**BBNPP Information Submittal AE-25:**

Written response presented during the BBNPP environmental audit and Figure 3.4-3B.

FIGURE 3.4-3B

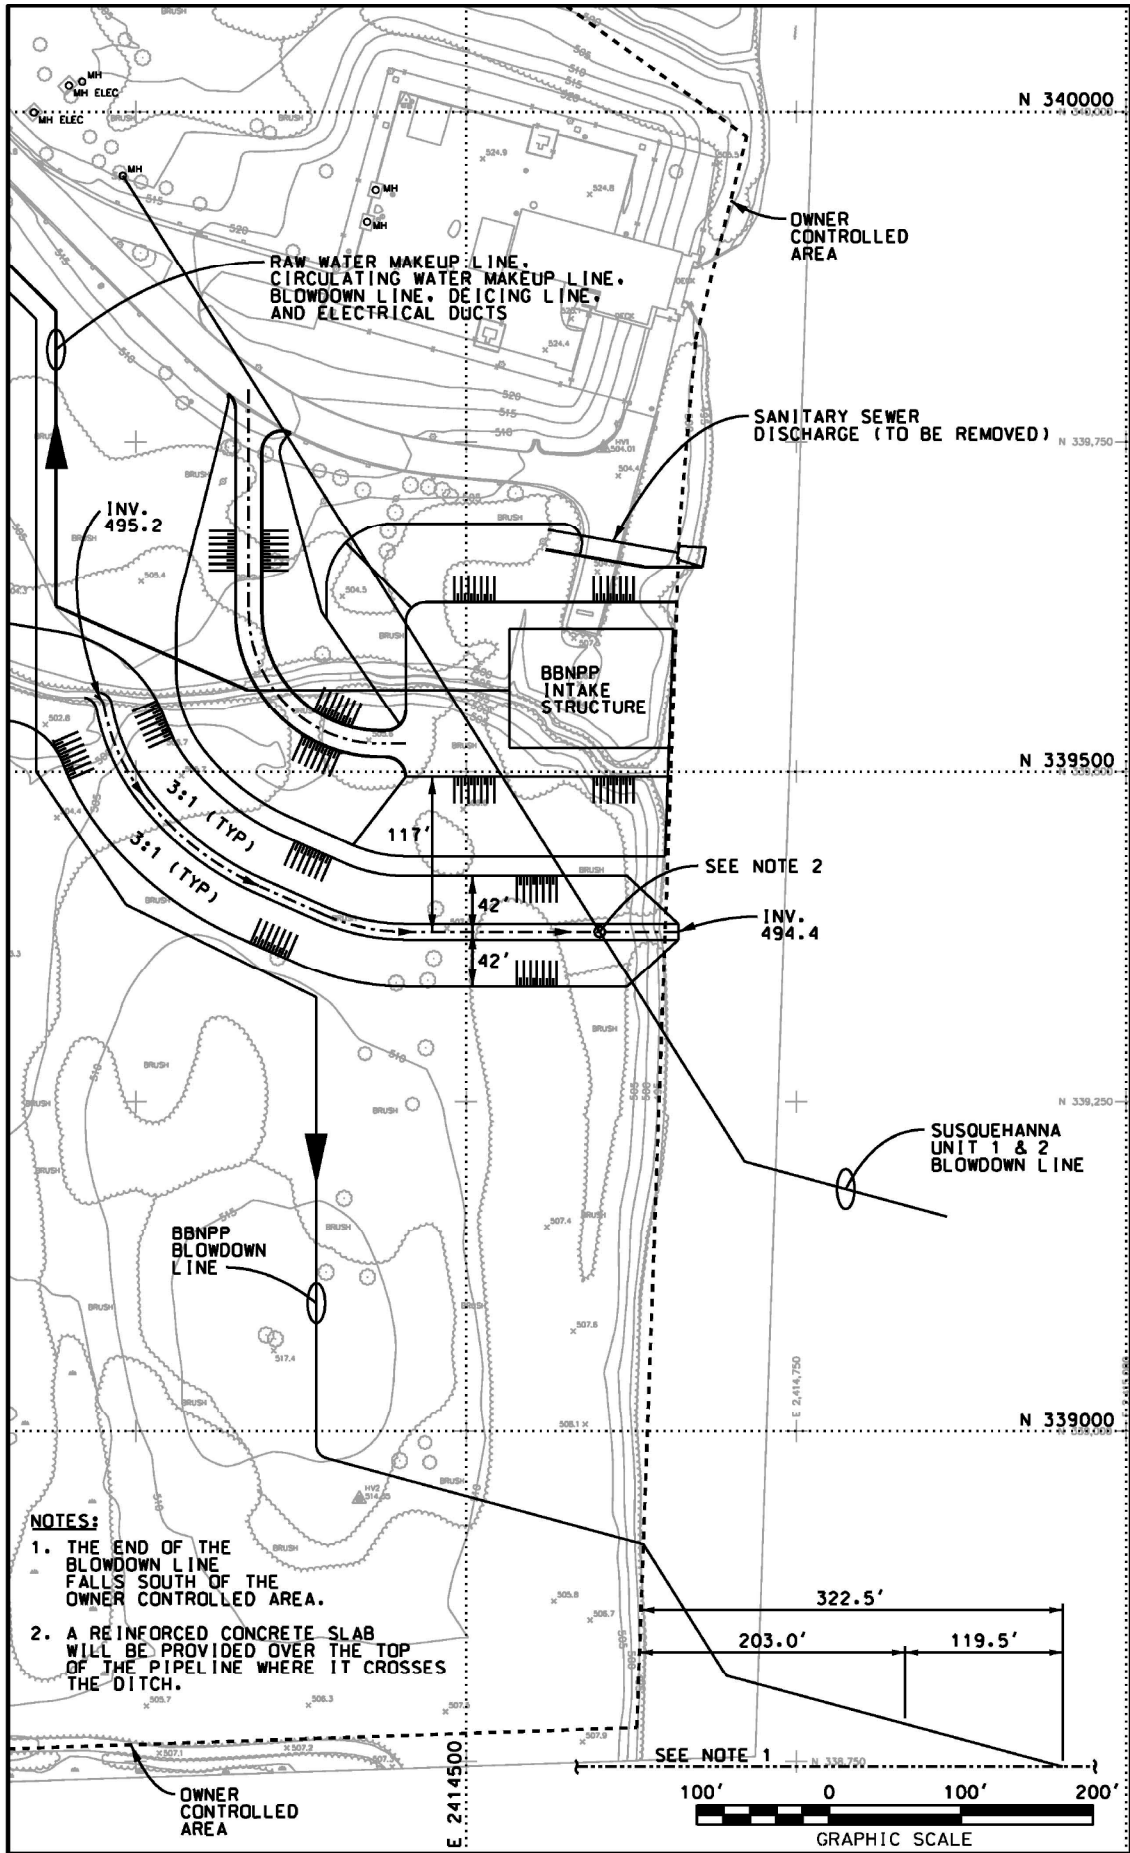
Provide a knowledgeable expert to discuss the relocation of a section of the ditch draining the Canal into the Susquehanna River, the “natural stream” model for the reconstruction, and potential monitoring of the reconstructed ditch.

Briefly, the ditch draining the Canal is a man-made structure that drains overflow from the Canal into the Susquehanna River. The ditch is a steep-sided structure that is cut down into the land surface. The ditch will need to be relocated for construction of the intake structure. The basic premise for reconstruction of the ditch would be to relocate it from its existing location and create a more natural stream channel using, for example, guidance provided by NC State University (2003). Instead of a steep sided channelized ditch, the channel would be reconstructed to mimic a more natural stream channel. The reconstructed channel would have a natural grade, mimic natural channel meanders, and incorporate habitat that would be beneficial to aquatic life. The riparian area adjacent to the new channel would be planted with native vegetation.

As discussed in ER Section 4.3.2, monitoring of the ditch post-construction could be completed once the new created channel has been colonized by aquatic organisms. Fish, amphibian, and benthic macroinvertebrate surveys could be completed to determine what type of organisms have colonized the created channel.
